Land at Bird in Eye Farm
South of Bird in Eye Hill
Uckfield

TRANSPORT ASSESSMENT SECOND ADDENDUM

Planning Reference: WD/2021/2198/MAO

MT/5330/TA2A.2
September 2022

DRAWN BY ARM		DESIGN BY ARM		CHK BY MT	
DATE 02/02/22		DRAWINGS No. 5330 / 021			REV No. H
SCALE 1:1000 @ A3

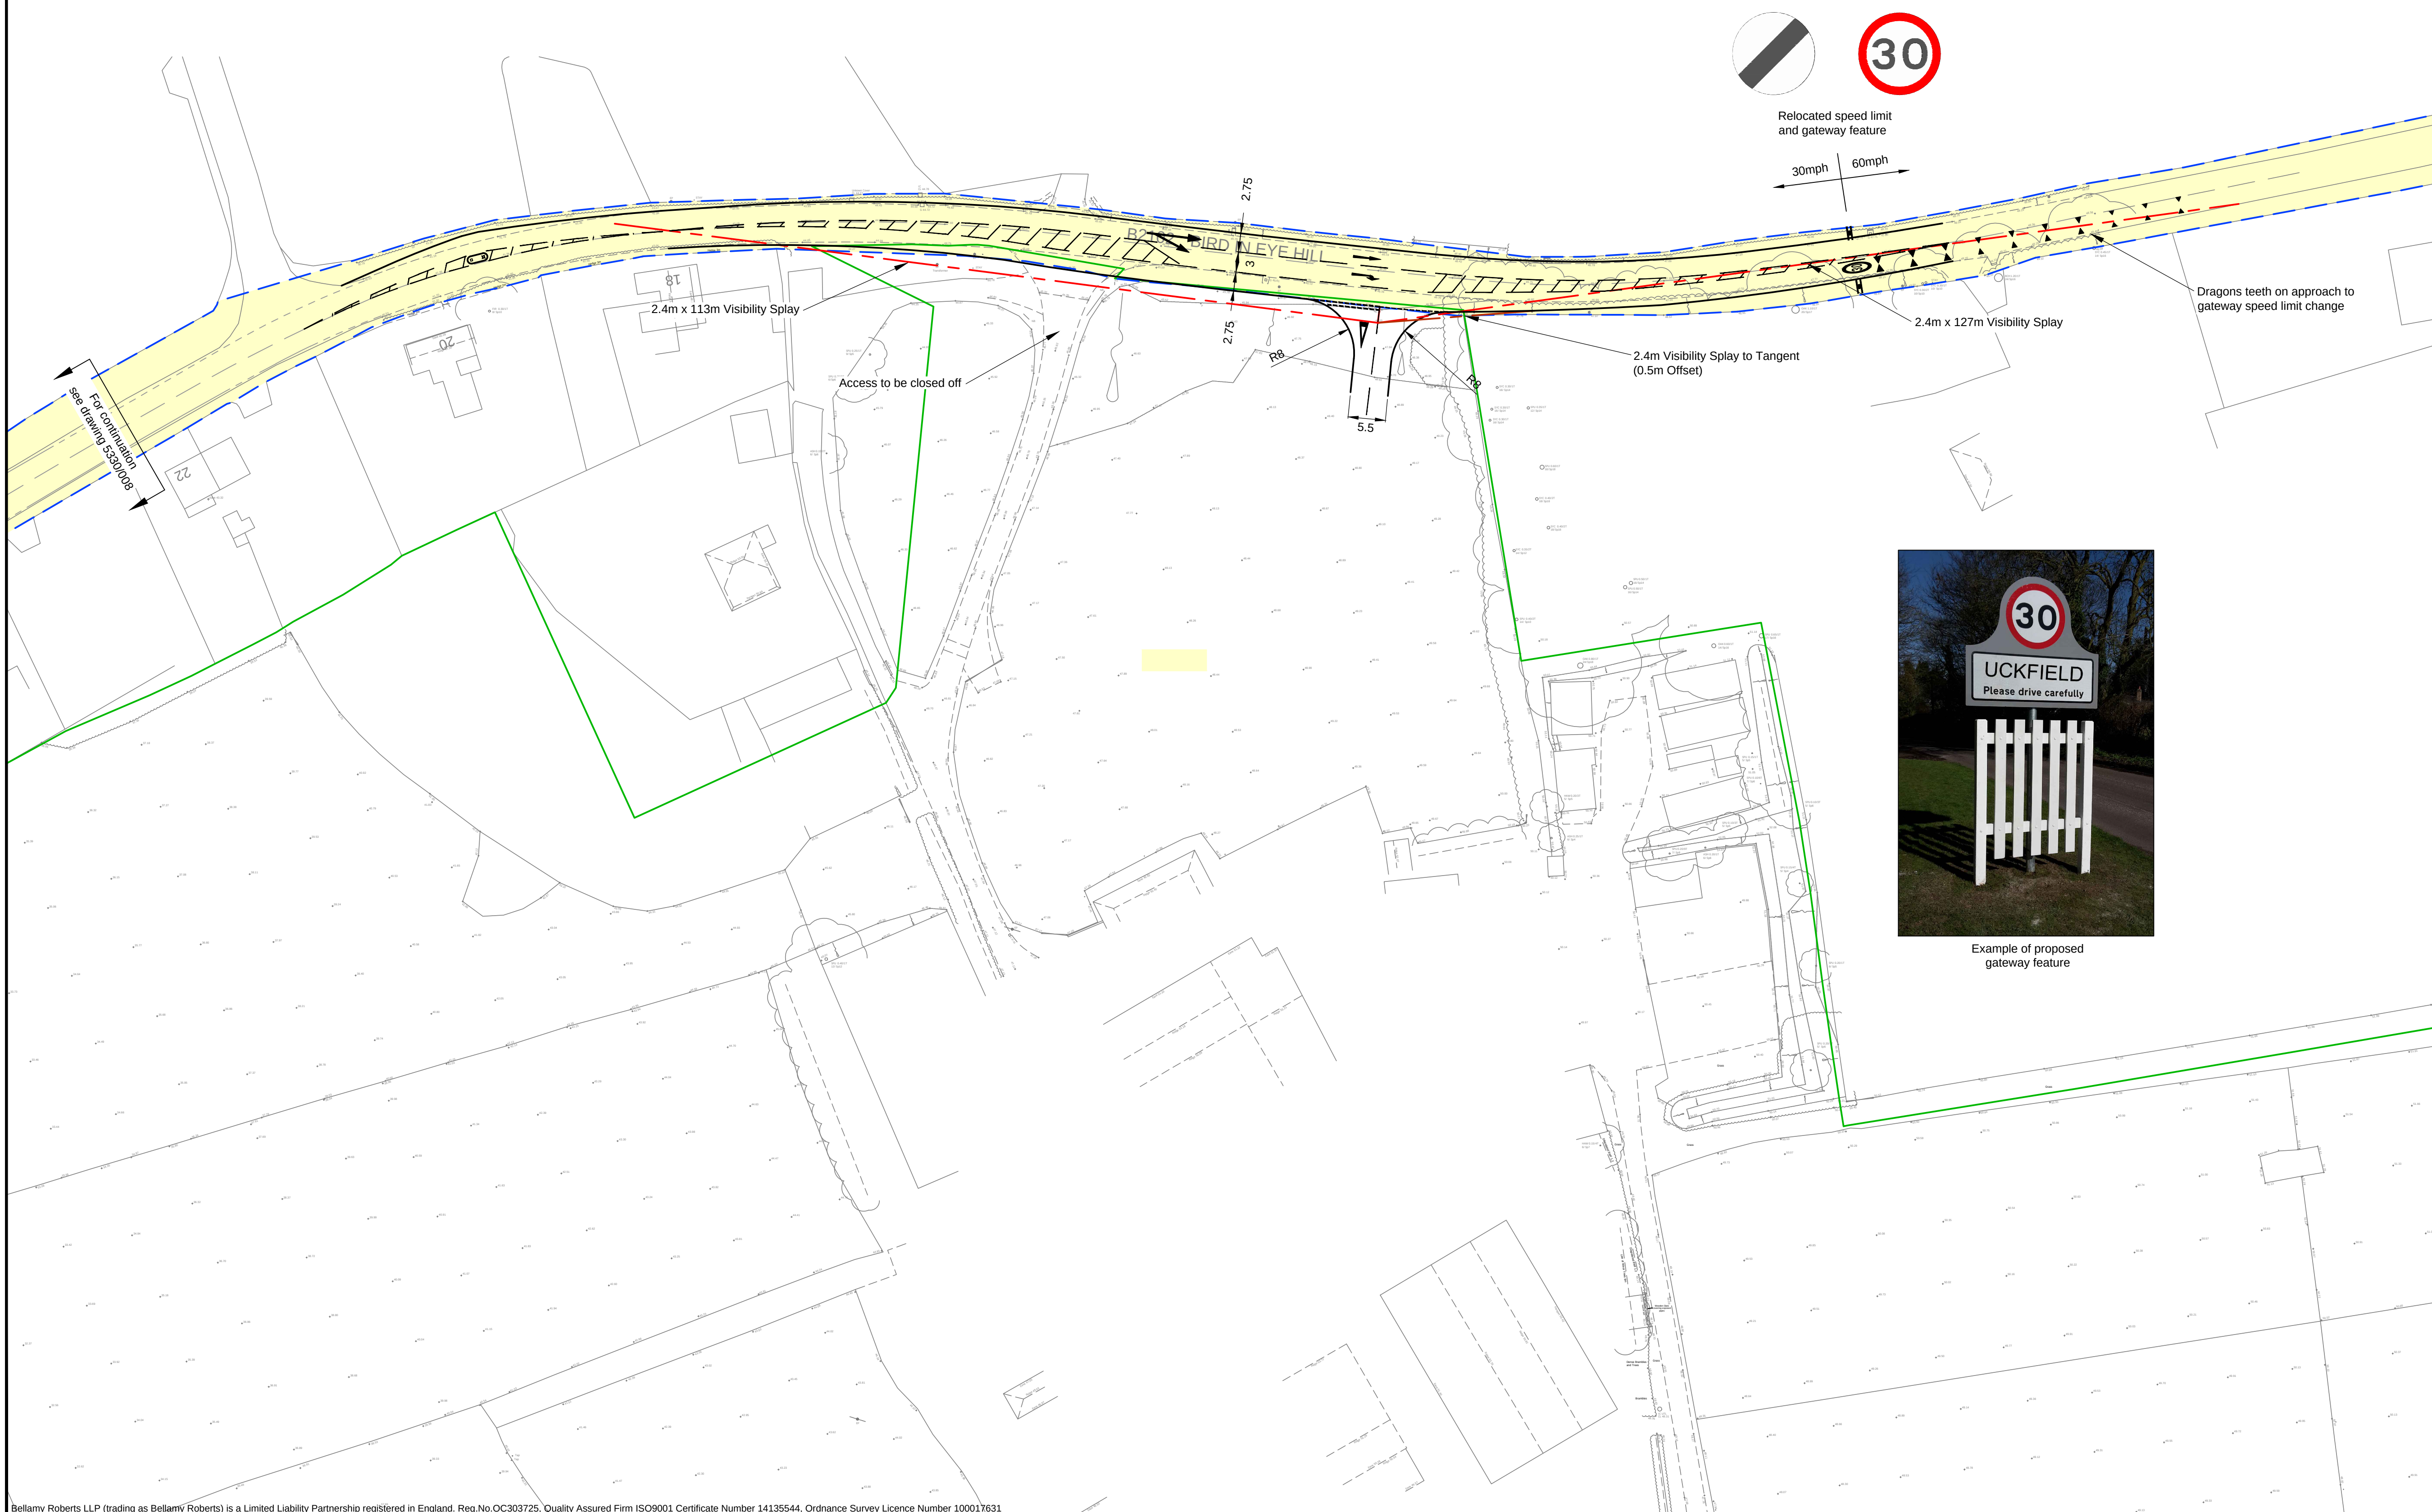
2.3 In their response of 12th May 2022, the CHA has stated that the access into the application site should incorporate a right turn lane for the reasons set out below:

2.20 A previous revision of this drawing was submitted to the CHA and comments were received on 22nd June 2022. In summary, the CHA advised that the 2.5m wide right turn lane (as proposed originally) does not meet DMRB design criteria as it's a new junction (ref. paragraph 6.10 of CD123).

2.19 Nevertheless, and to assist the CHA in providing a positive recommendation for the scheme, the site access arrangement has been revised to incorporate a right turn lane (see drawing 5330/021 Rev. H, at **Appendix 3**).

2.21 The proposal has been revised accordingly and the scheme as proposed at Appendix 3 incorporates a 3m wide right turn lane to accord with DMRB CD123 guidance. The through lane widths have been maintained at 2.75m which is consistent with the existing road widths along this section of Bird in Eye Hill.

2.22 The tapers shown are 1:25 (ref. Table 6.1.1 from CD123) which are commensurate to a design speed of 85kph (52mph). The recorded speeds as per the 2019 ATC survey were 42.4mph eastbound and 45.9mph westbound. If the CHA maintain that a right turn lane is necessary to allow safe and suitable access to be achieved to the application site, it is evident that such an access can be provided which accords with all relevant design criteria and is not dependant on the proposed extension to the 30mph speed limit.

CLIENT	Croudace Homes Ltd.	DATE	11/01/22
PROJECT	Bird in Eye, Uckfield	DESIGN BY	MT
TITLE	Proposed Access Simple Priority T-Junction	DRAWN BY	ARM
		CHECKED BY	MT
DRAWING No.	5330 / 020	SCALE	1:1,000 @ A3
		REV No.	F

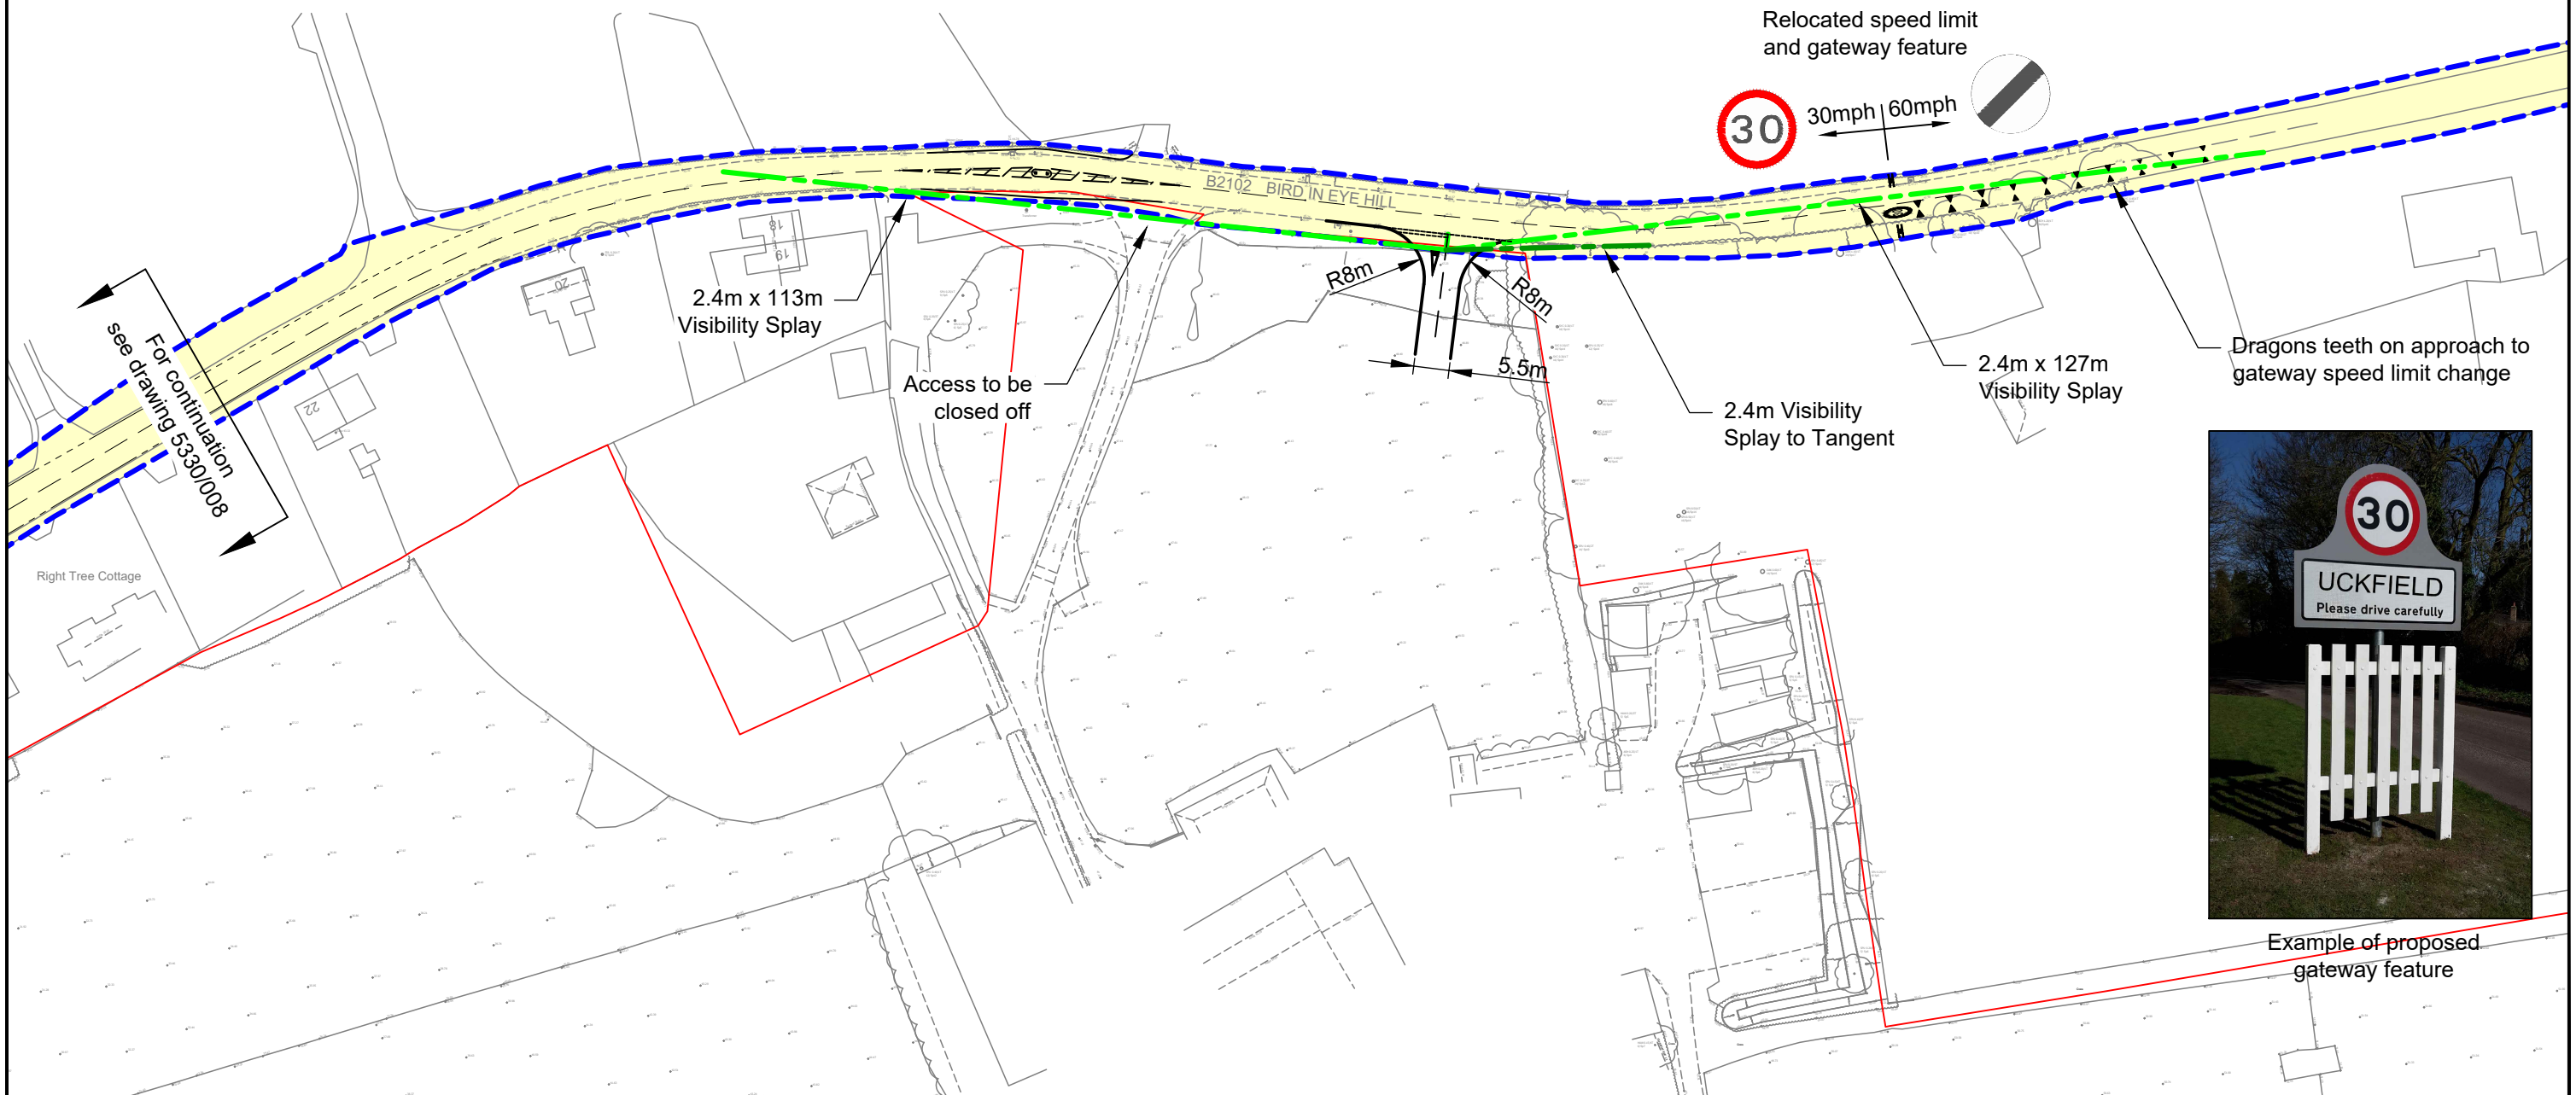
2.23 The CHA has requested visibility splays of 113m to the west and 127m to the east from an x-distance of 2.4m, which correspond to the Desirable Minimum distances as per DMRB guidance, albeit these include an allowance for bonnet length which is not a requirement for y-dimension.

2.24 Nevertheless, and to assist the CHA, the requested visibility splays have been provided. To accommodate the requested visibility splays, the proposed site

access has been relocated approximately 20m east of the position previously shown. The requested visibility splays are achievable at both the ghost island right turn lane and simple priority T-junction. See Appendix 3 and **Appendix 4** respectively. The requested visibility splays can be achieved and do not require third party land.
